02-209195  
**PERMIT**

**SEWAGE DISPOSAL SYSTEM**  
HOWARD COUNTY HEALTH DEPARTMENT  
BUREAU OF ENVIRONMENTAL HEALTH  
410-313-2640

UBDIVISION Skyview LOT NUMBER 5 ADDRESS 9409 Old Frederick Road

514958

SYSTEM

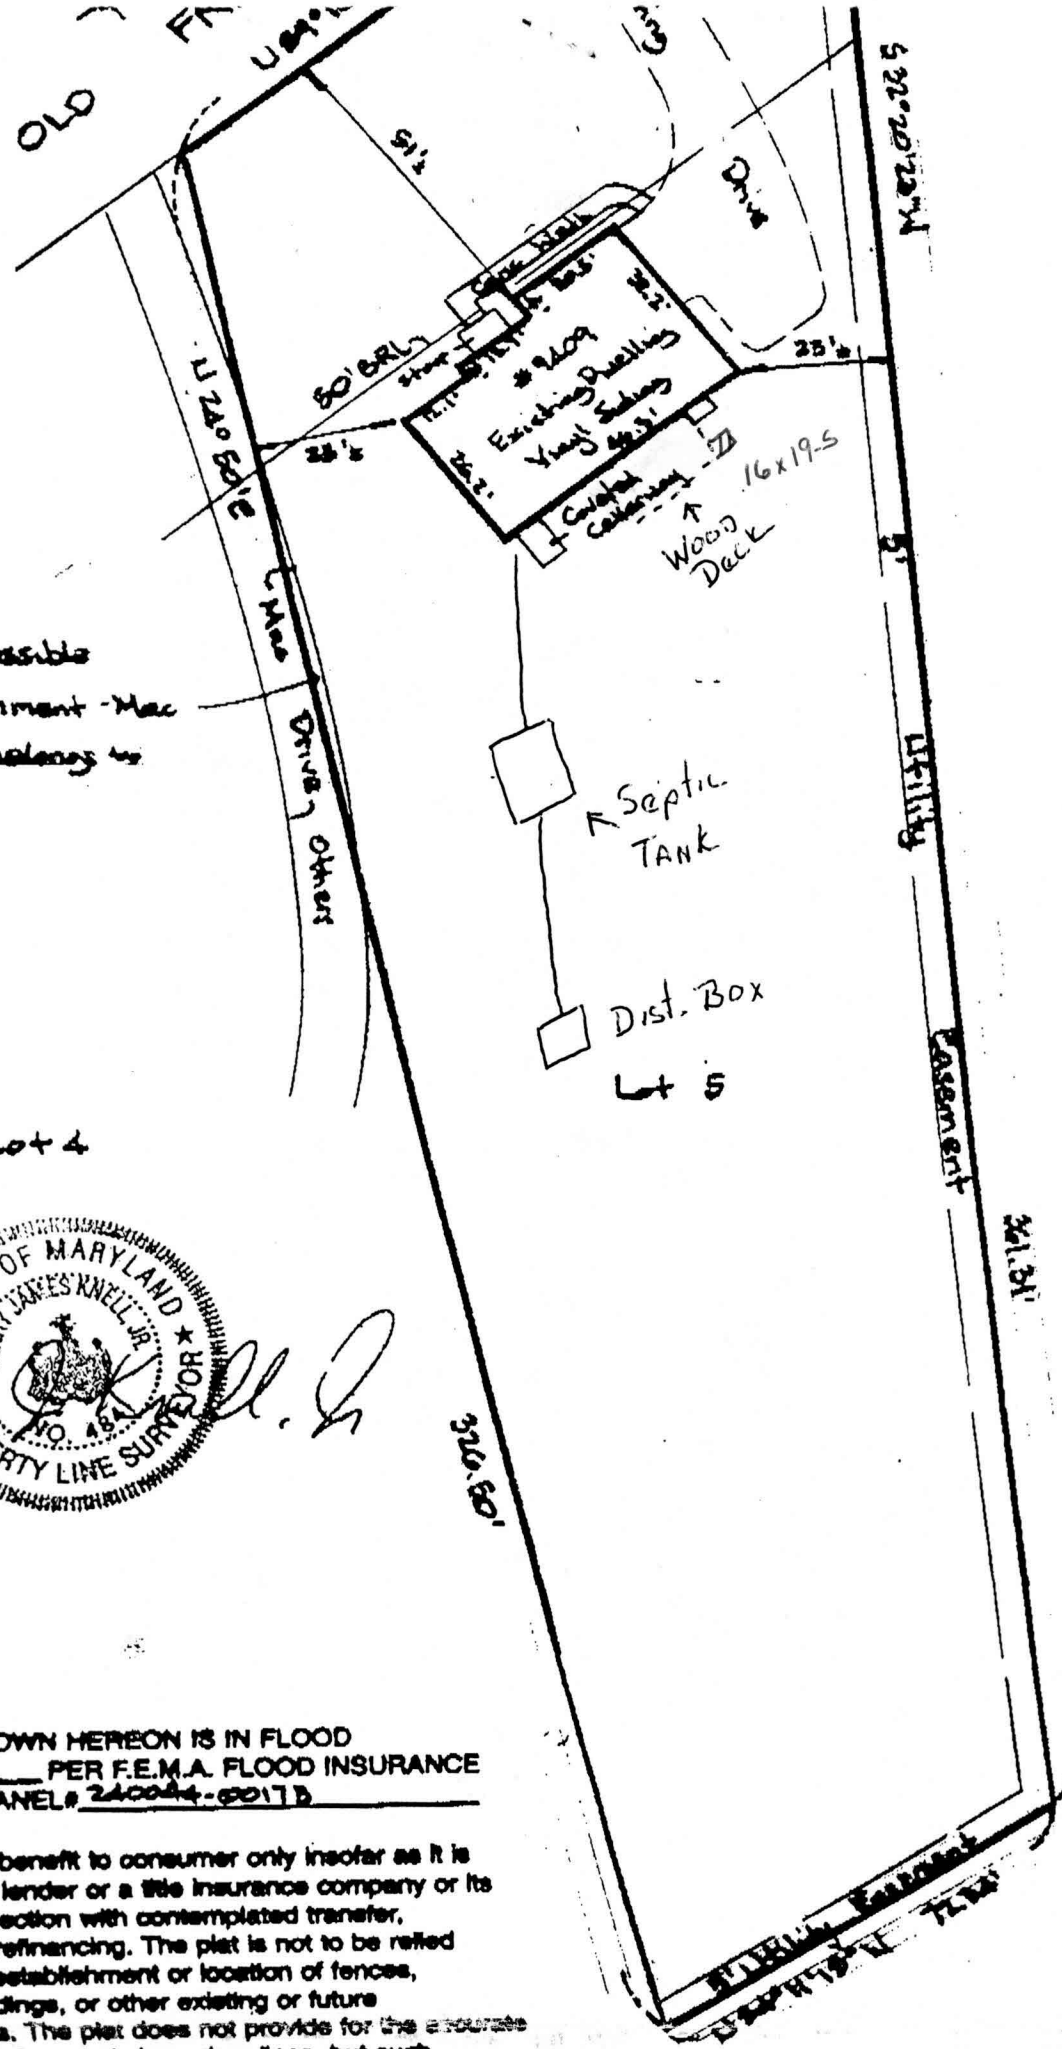
3/27/01 - SPECS CHANGED BY BRIAN BAKER (SRN)

4/1/01 - MER ALLOWED 6" DEEPER ON TRENCHES AND INLET (SRN)

4/20/01 - LEACHING BED DESIGNED DUE TO UNEXPECTED ROCK (SRN)

Old Frederick Road  
 PRE-CONSTRUCTION INSPECTION: 3/27/01 Can't make gravity to top of easement.  
Owner to reconfigure easement and submit new perc. cert. 3-80' trenches  
 INSPECTION COMMENTS: inlet no deeper than 6', 2' of stone, (BB)  
3/29/01 A.M. OK to cover from house to septic tank. contractor not on site - no other work done. DKC 4/20/01-ROCK ENCOUNTERED IN LOCATION (A) (SEE PROFILE), ROCK ENCOUNTERED IN (B) SEE PROFILE (MORE EASEMENT LOST).  
LEACHING BED DESIGNED (3), ENOUGH REPAIR AREA EXISTS IN EASEMENT TOWARDS HOUSE, REVISE PERC CERT NECESSARY EVEN THOUGH PUBLIC SEWER MAY BE AVAILABLE SOON, (SRK)  
4/23/01-SYSTEM COMPLETE, OK TO COVER ALL WORK (SRK)  
 INSPECTOR Steven R. Krieg DATE SYSTEM APPROVED 4/23/01
